Technical Note

Project:	Harlington School, Pinkwell Lane, Hayes UB3 1PB		
Prepared by:	S. Pond	Date:	19 August 2024
Approved by:	A. Watts	Checked by:	A. Watts
Subject:	Preliminary Remediation Validation	Ref:	737604-1(00)

TITLE: **Figure 2:
 Exploratory Hole Location Plan**

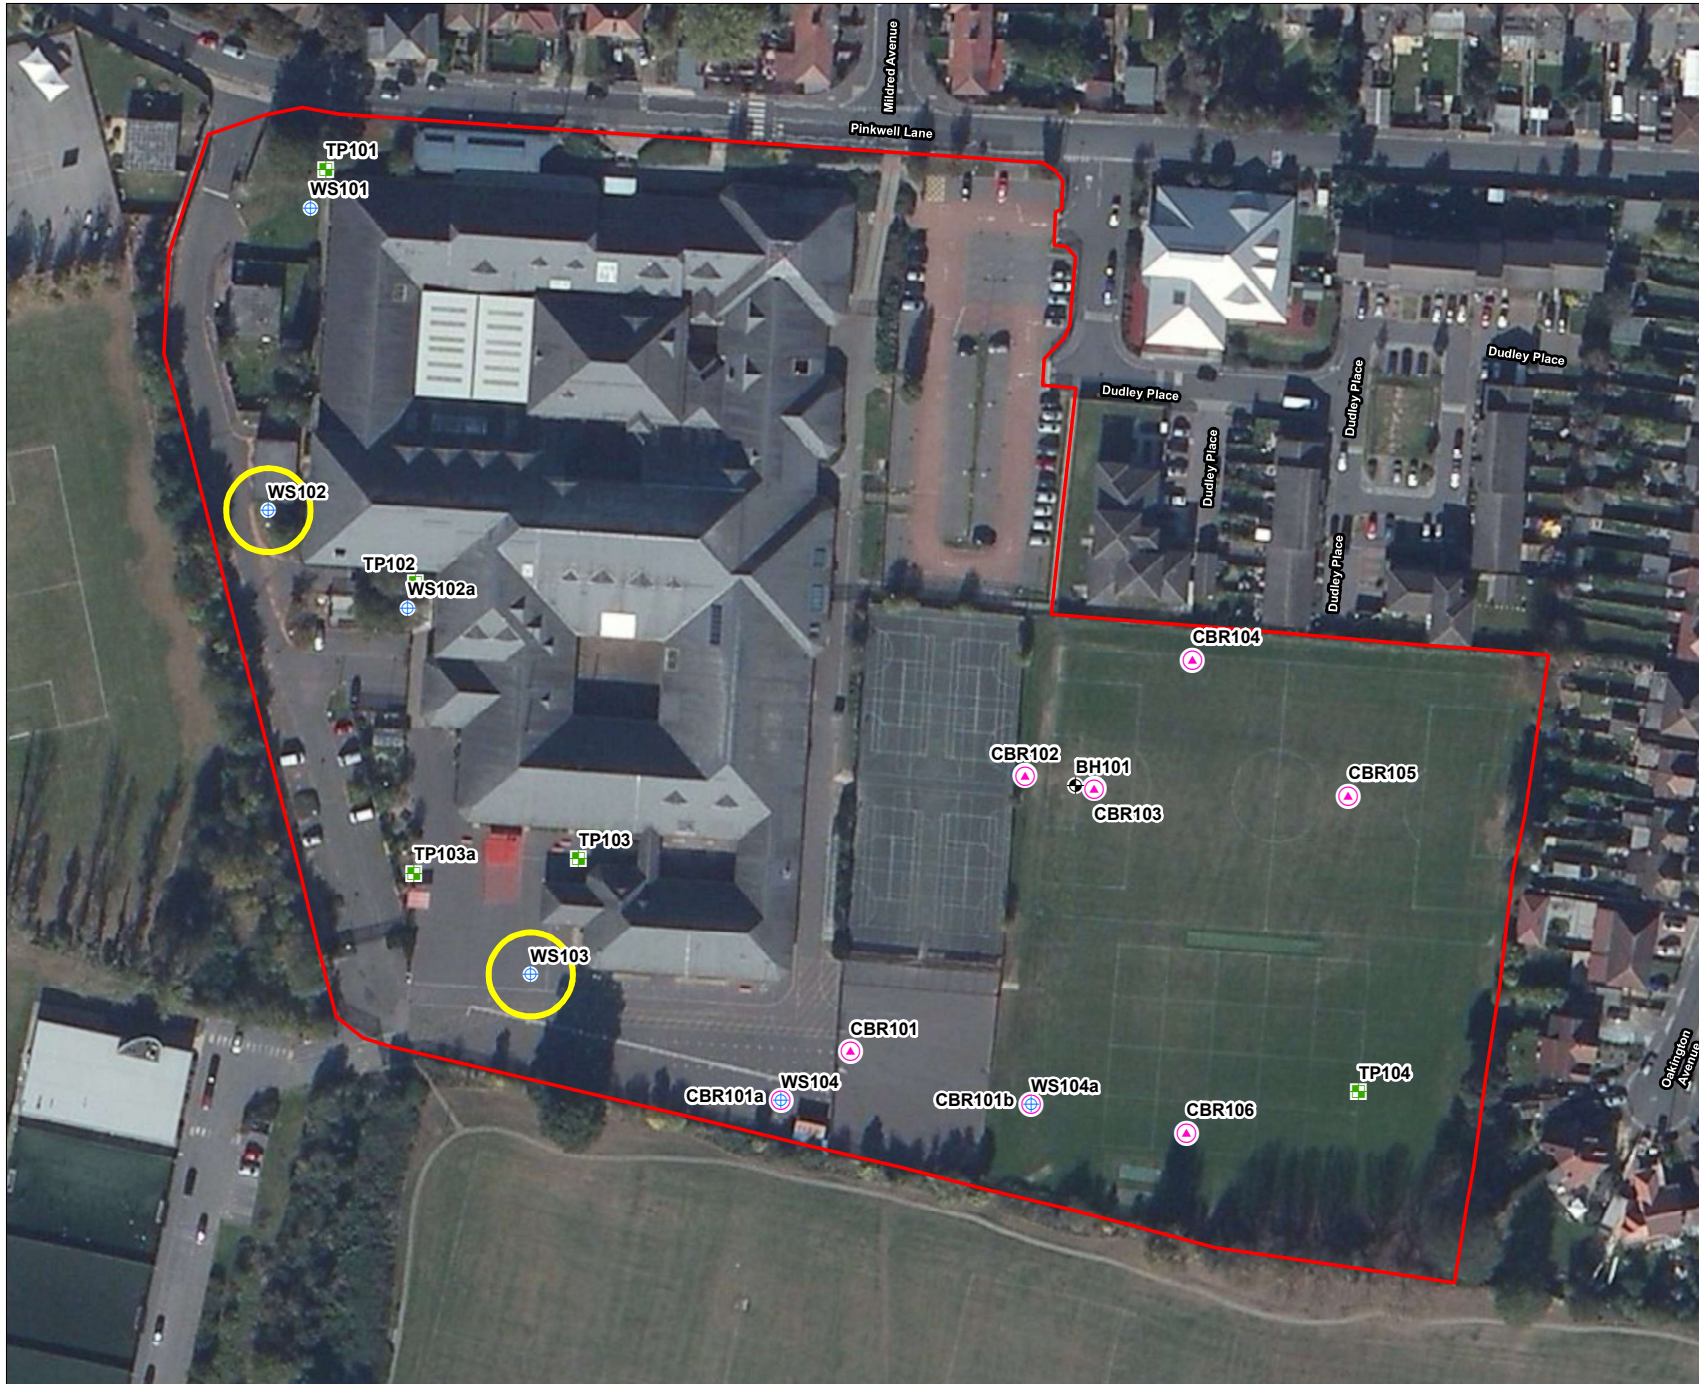
WS102 is set within a 9 m by 12 m area grassed area of soft landscaping which is to be retained and falls within the red-line boundary. It has become apparent that site constraints in the vicinity of WS102 mean that delivery of this approach is not practicable due to the presence of a protected tree with Wates (Principal Contractor) reporting a conflict between the required excavation for source removal and the root protection zone for this tree.

Wates have consulted with their arboricultural consultants and now propose an alternative method of remediation to be used across the whole 12 m by 9 m area of soft landscaping to break the pathway and remove the potential contaminant linkage.

This would be accomplished by carefully removing the existing turf to minimise damage to the tree roots and then applying a proprietary bonded granular rubber mulch (<https://www.abacuspg.co.uk/bonded-rubber-mulch/>). This would be fully permeable to water and air and durable with the appearance of shredded wood bark mulch. The mulch layer would prevent exposure of site users and the public to the site soil, without damaging the roots of the tree.

Validation of the remediation of this area could then be achieved by the contractor supplying photographs of the finished area, a delivery note or invoice for the rubber mulch material, and waste characterization and disposal documentation for the removed turf.
